Re: St. Lucie Units 1 and 2
Docket Nos. 50-335 and 50-389
Proposed License Amendments
EDG Risk Informed AOT Extension
Response to Second Request for Additional Information

Request for Additional Information
Related to the Amendment of the Technical Specifications
for the Emergency Diesel Generators
St. Lucie Units 1 and 2

FIGURE 1
Blackout Crosstie Bus Arrangement

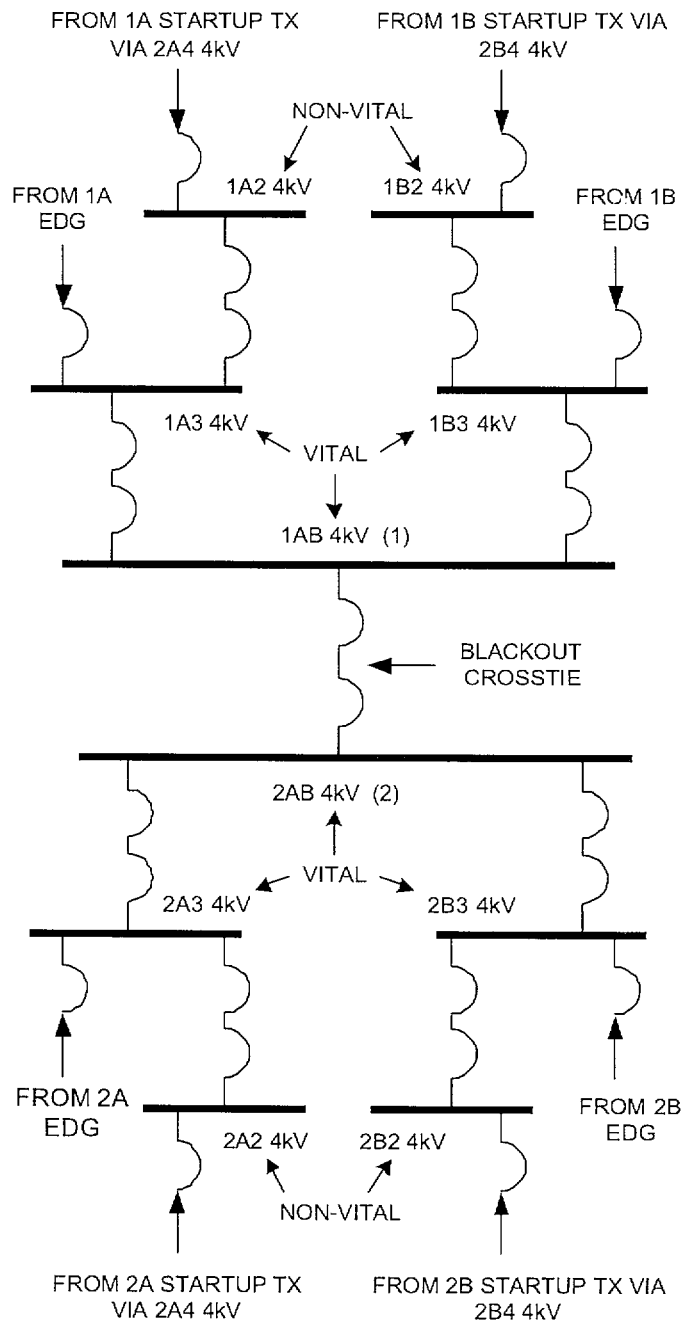
Your submittal indicated that it was "judged" any potential risk impact of the proposed change due to internal fires would be "very small." Later, there was a small discussion on your off-normal operating procedures in response to fire; however, no further specific discussions were provided to justify the conclusion that the risk impact of the change would be small. Meanwhile, your IPEEE submittal estimated that the core damage frequency (CDF) due to fire was $1.9E-4/\text{yr}$, which was significantly higher than the CDF due to internal initiating events. There were three rooms that were screened in for detailed evaluations, which include control rooms, cable spreading rooms, and 'B' switchgear room. Please justify your conclusion by describing your technical basis for the judgment that the risk impact due to fire would be very small in terms of risk measures, i.e., change in CDF and incremental condition core damage probability (ICCDP) for a single 14-day outage, used in Regulatory Guides (RG) 1.174 and RG 1.177.

The St. Lucie probabilistic safety assessment (PSA) models used to calculate the estimated internal events risk impact of the proposed allowed outage time (AOT) extension do not include an assessment of the potential risk due to internal fires. The following provides a scoping estimate of the impact on the fire risk due to the proposed AOT change. Note that the fire risk is only estimated for the preventative maintenance (PM) case since PM would provide the greatest exposure to unavailability that might extend beyond the present 72-hour AOT. Figure 1 is a diagram of the St. Lucie Plant electrical distribution system showing the station blackout crosstie arrangement.
